Beck Park Expansion – Phase 1

Bid # 25-11

ADDENDUM No. 4

April 17, 2025

sheet number
C5.02

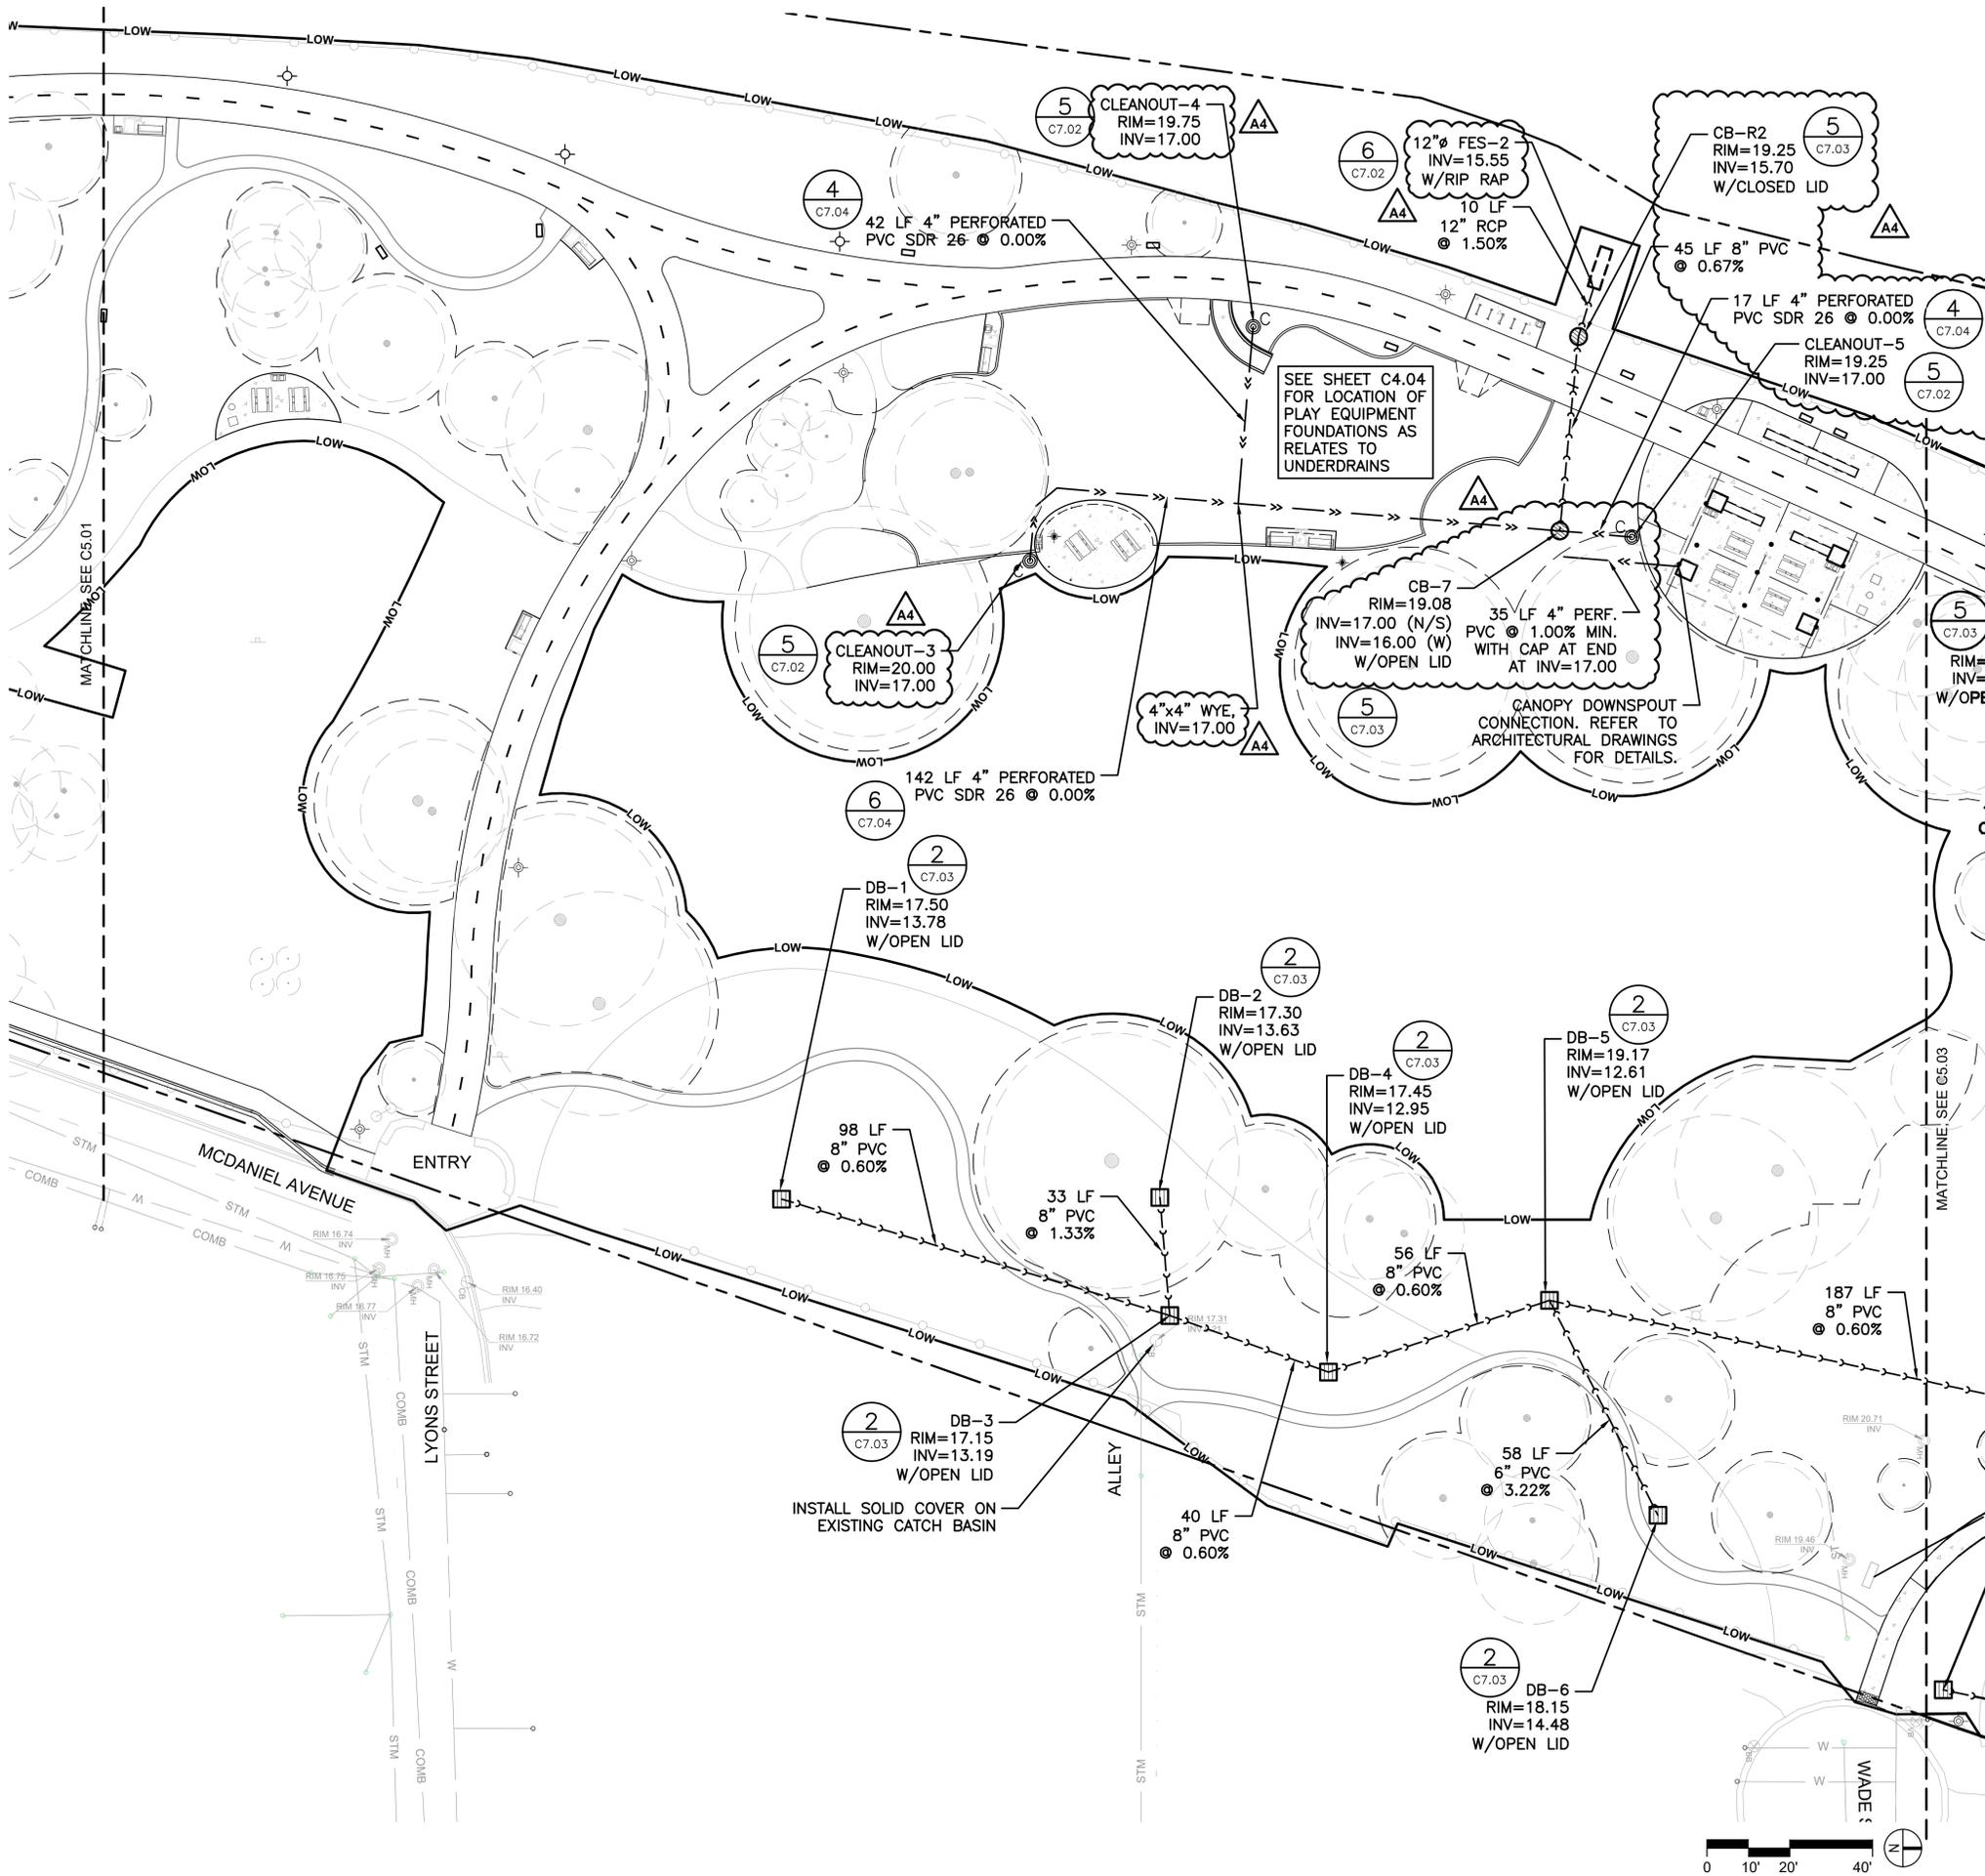
- Revised playground underdrainage per updates to sheet C4.04 and adjusted adjacent storm sewers accordingly.
- Revised pavilion canopy downspout/sewer outfall design to include infiltration trench with underdrainage piping.
- Replaced outlet control structure (including custom vortex restrictor) with standard catch basin.

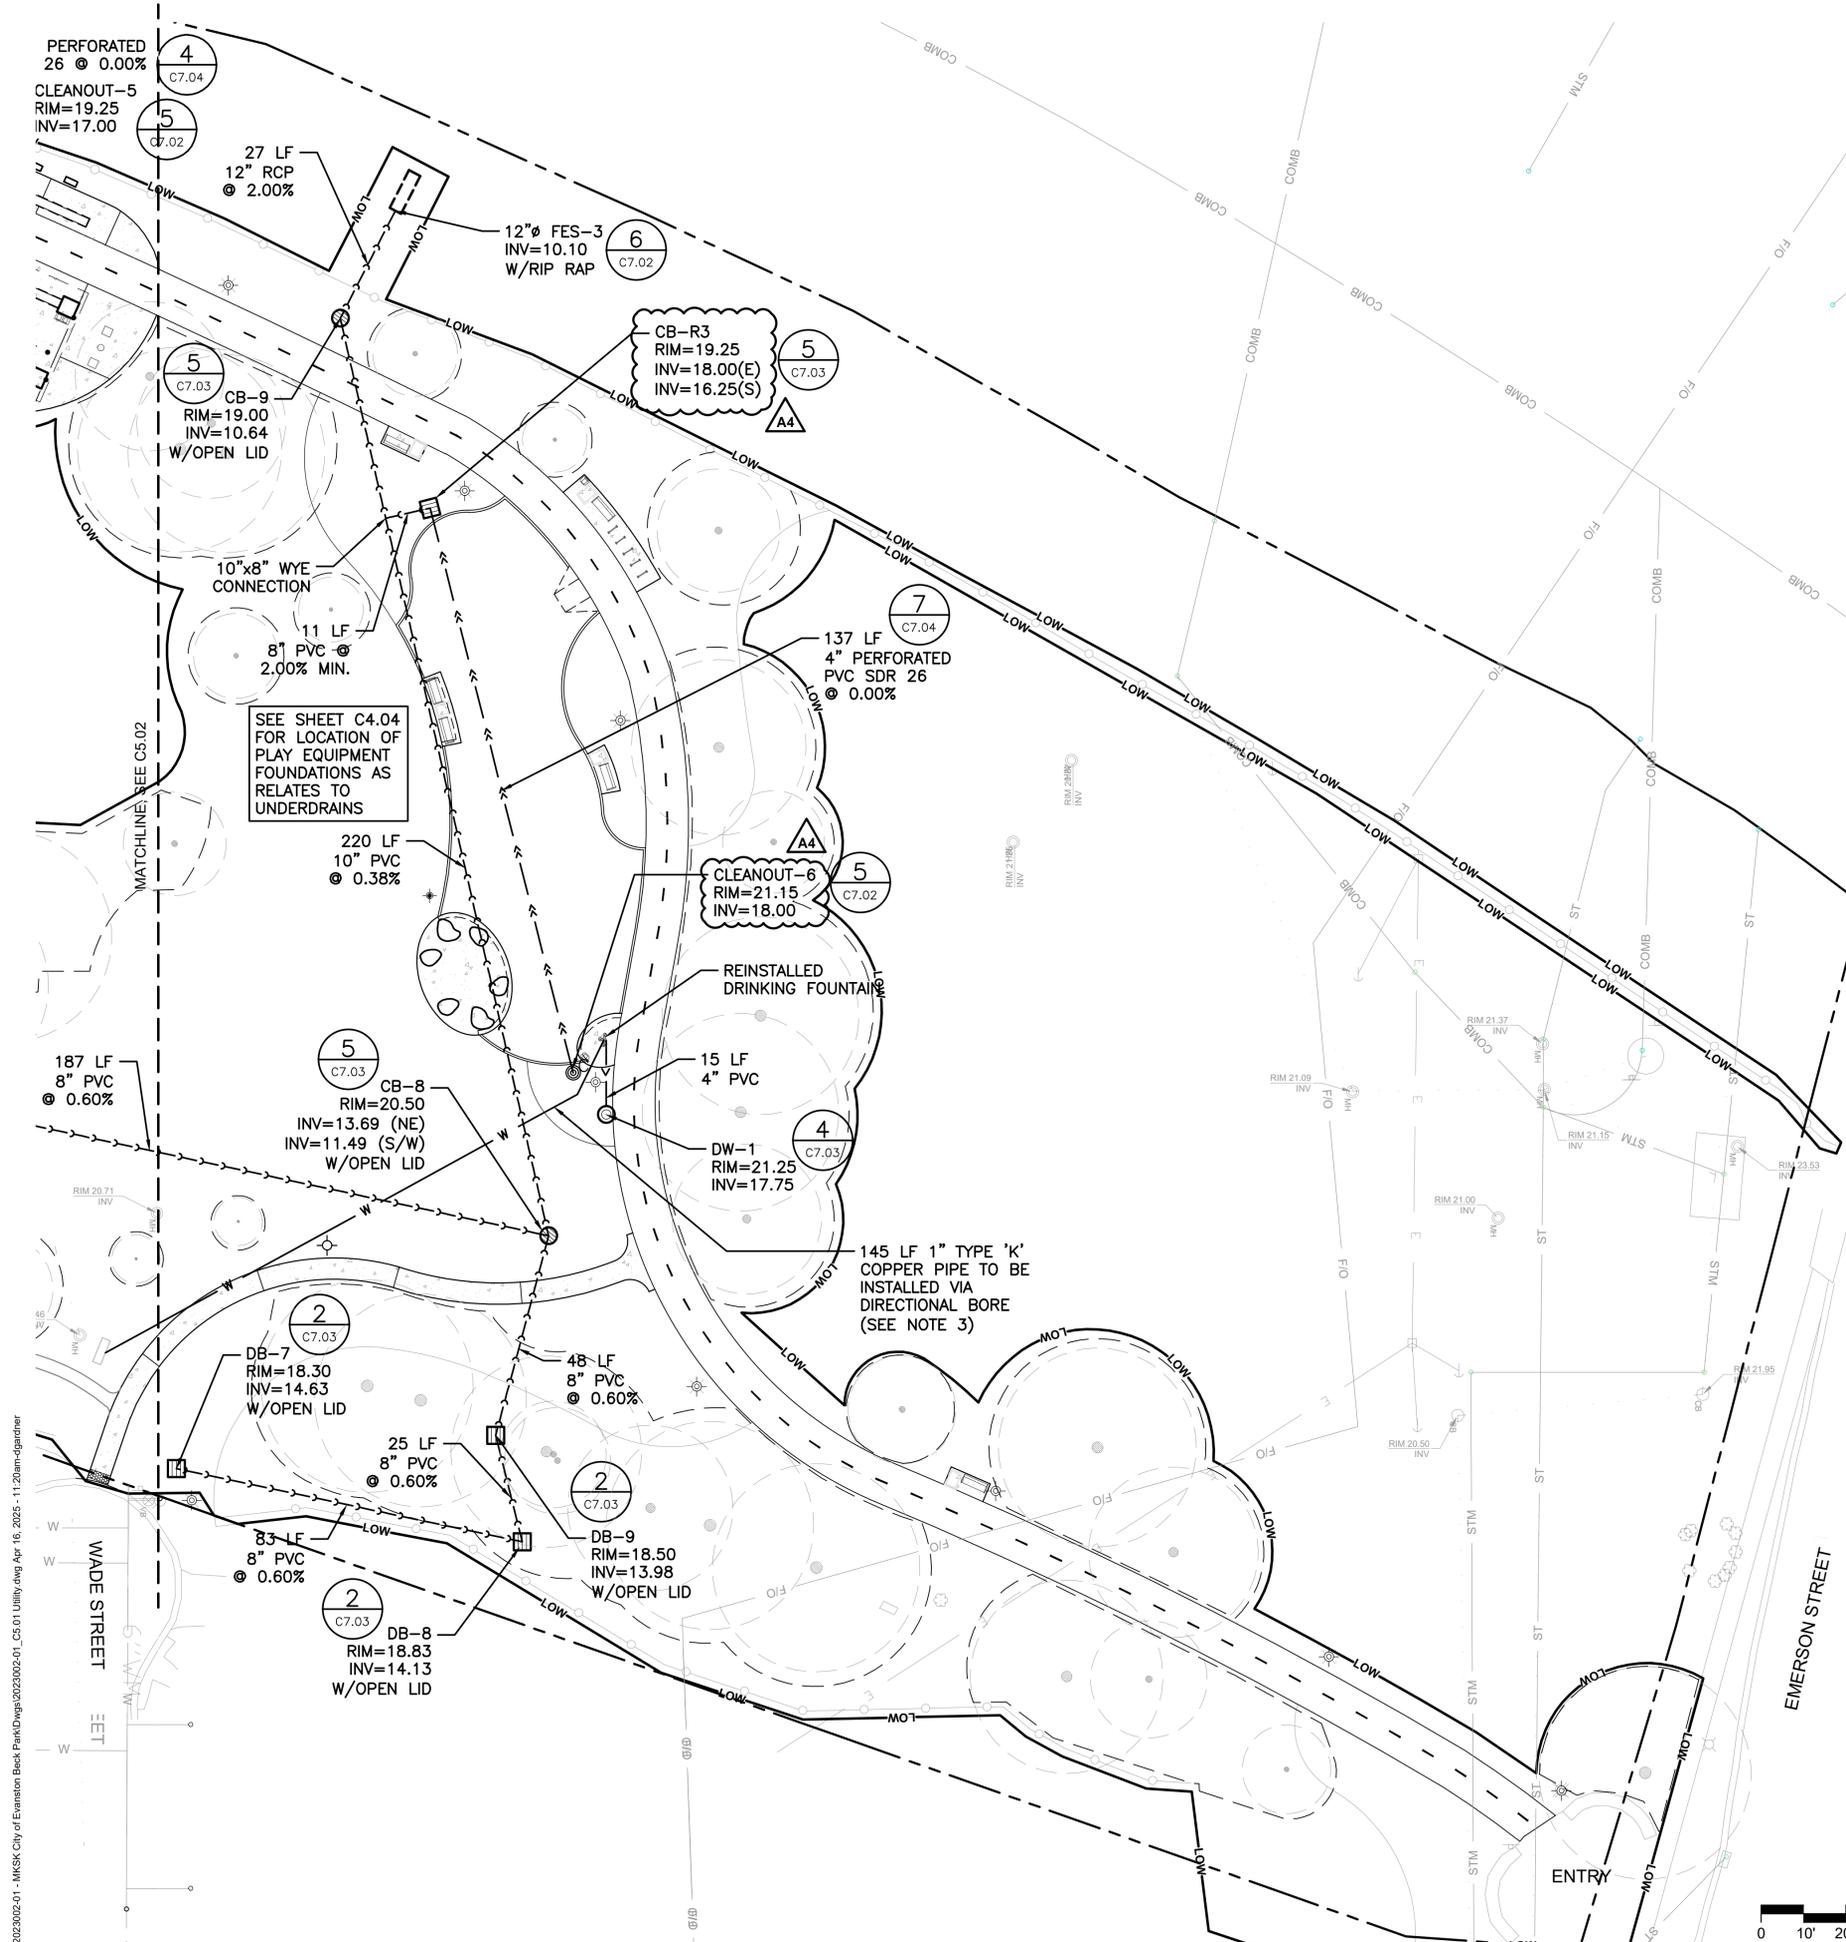
- Revised playground underdrainage per updates to sheet C4.04 and adjusted storm adjacent sewers accordingly.
- Replaced outlet control structure (including custom vortex restrictor) with standard catch basin.

1 PLAYGROUND AREA INFILTRATION TRENCH DETAIL – AREA 2 (SOUTH)
 C7.04 SCALE: NOT TO SCALE

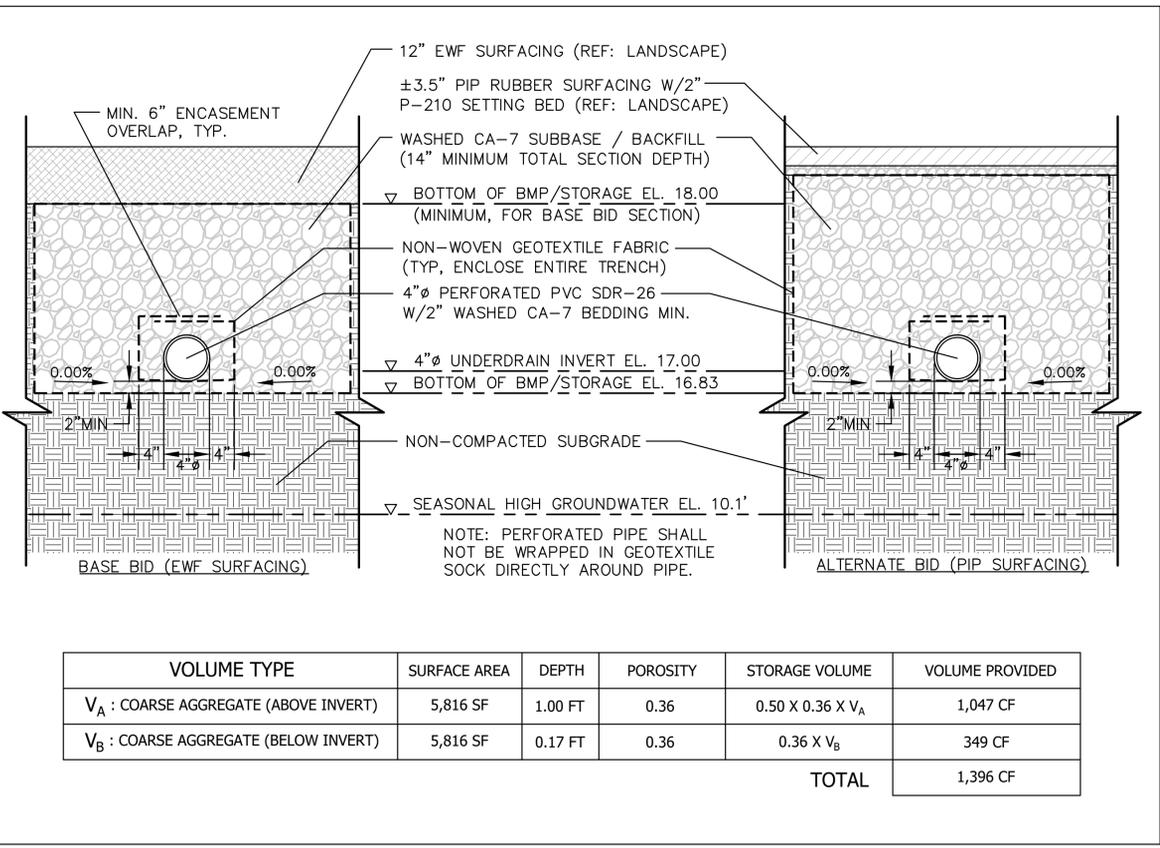
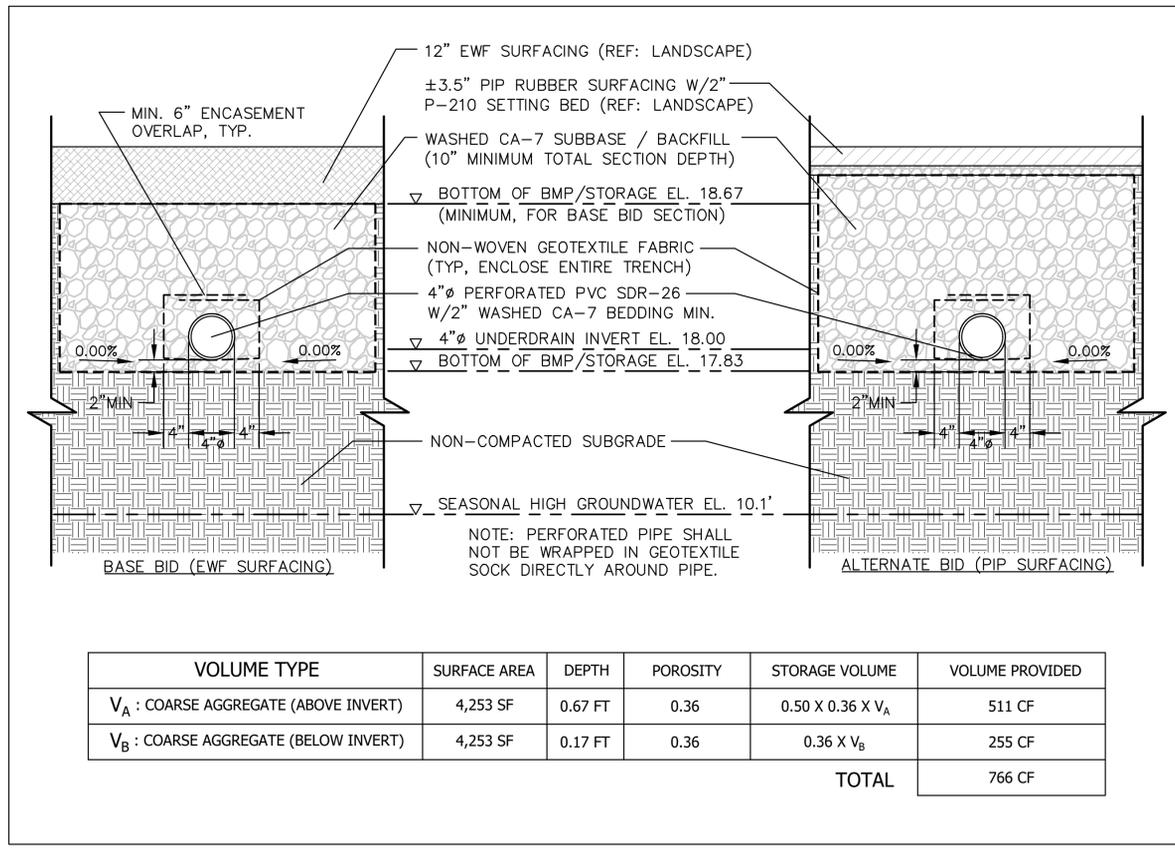
- Revised infiltration trench details to coordinate with revisions to sheets C4.04, C5.02, and C5.03.
- Removed outlet control structure and vortex restrictor details.

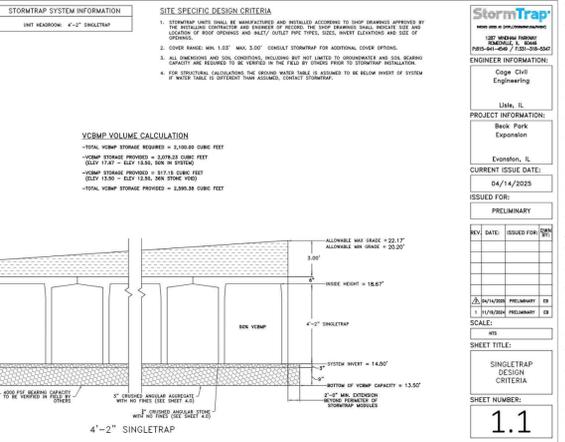
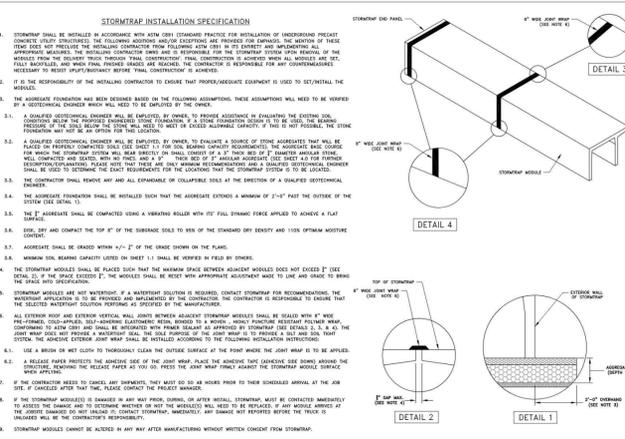
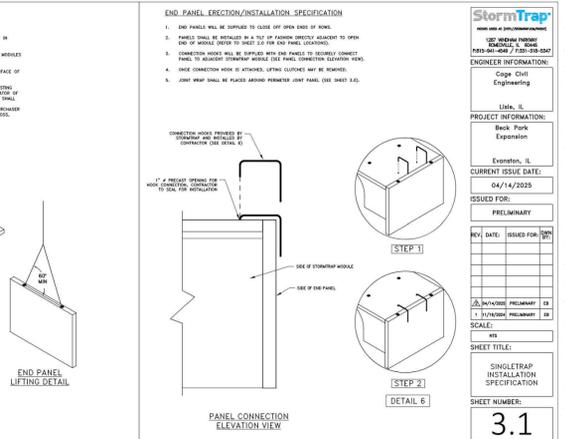
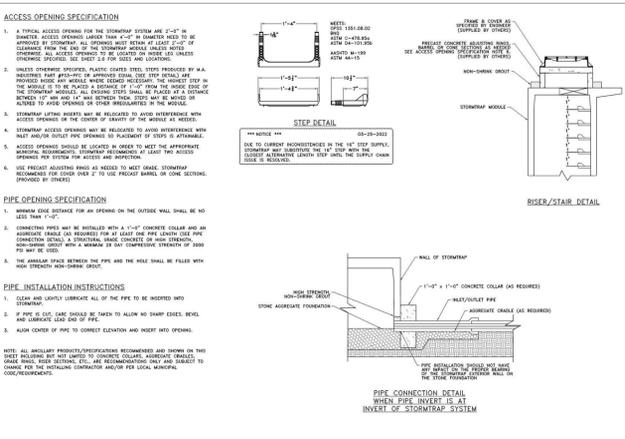
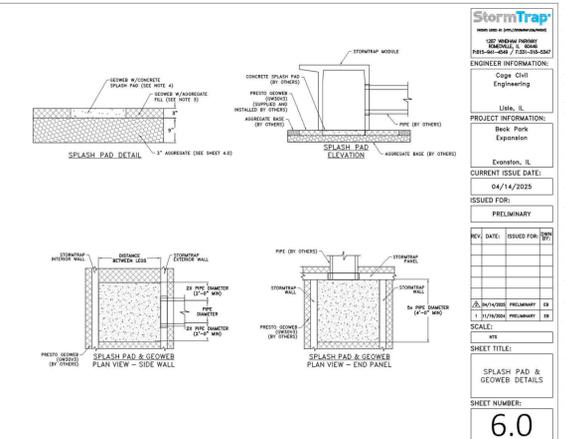
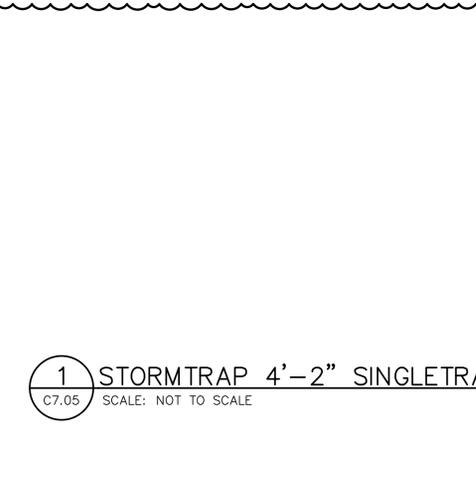
- Revised StormTrap system detail drawings to coordinate with revisions to sheet C5.01.
